Author's response to anonymous referee #1

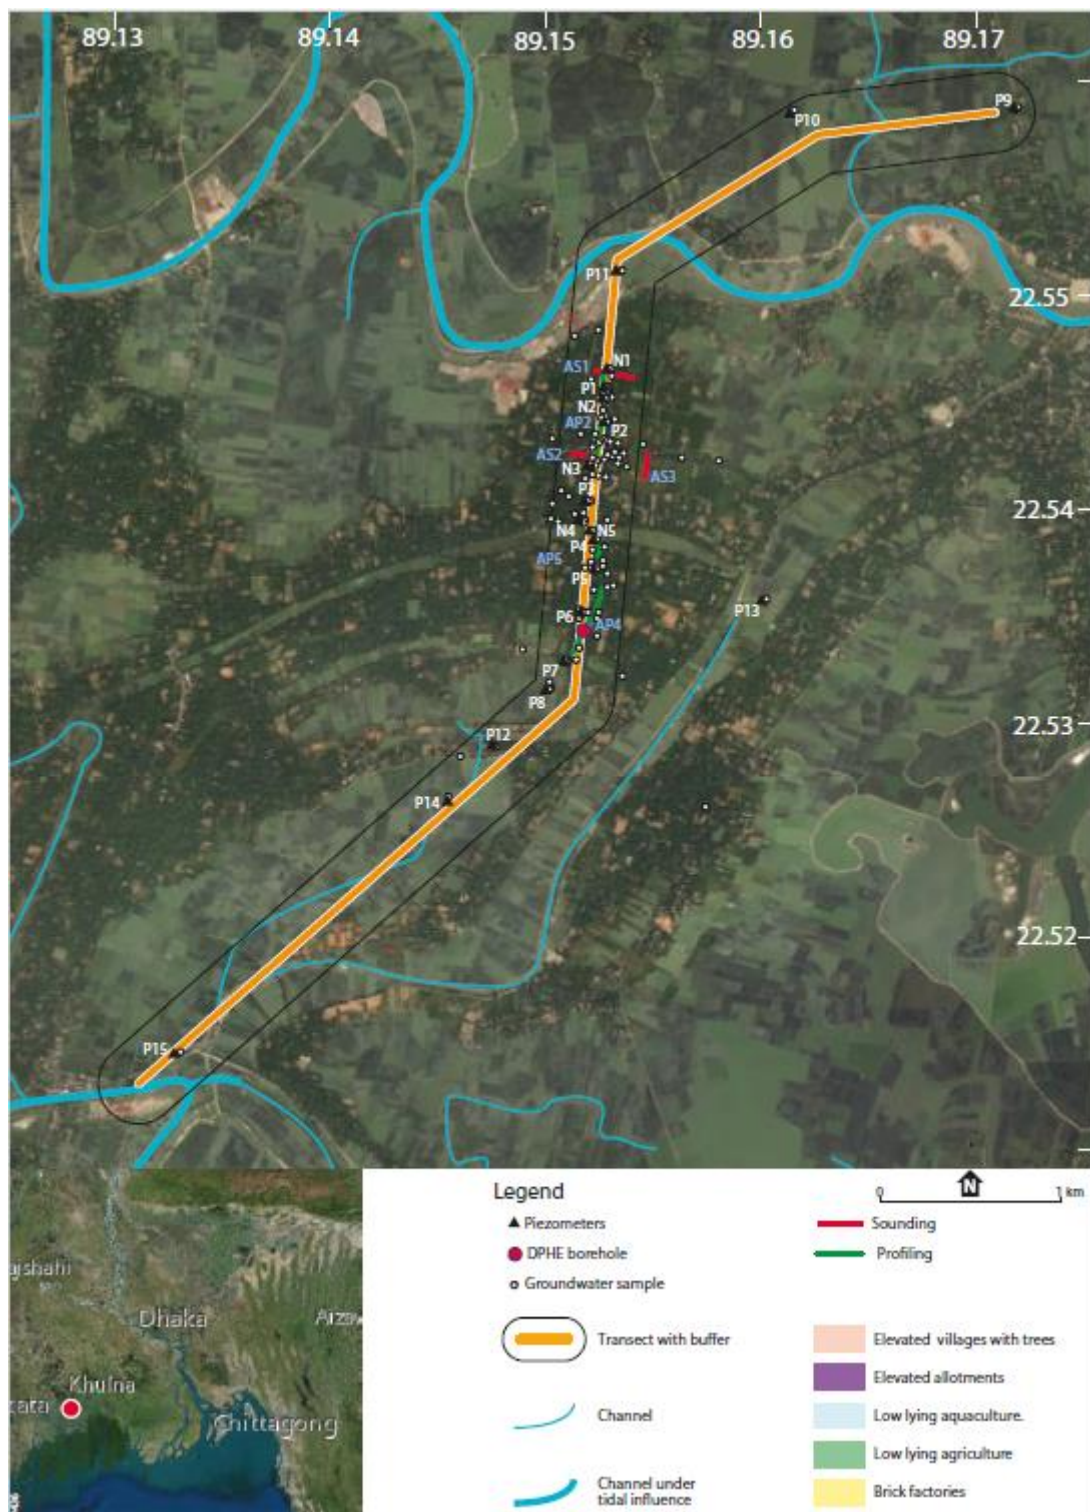
2. Reviewer's comment: Figure 1 seems insufficient for the reader to fully understand the field site. An additional satellite image would give the reader a better sense of the region. Perhaps consider a two-paneled figure with a satellite image adjacent to the site diagram. An additional figure in an appendix would also suffice.

Author response: We agree that we can be more clear.

Changes in manuscript: We will add a figure with satellite imagery, either in the appendix or as a two-paneled figure. The following figure with satellite imagery will be added
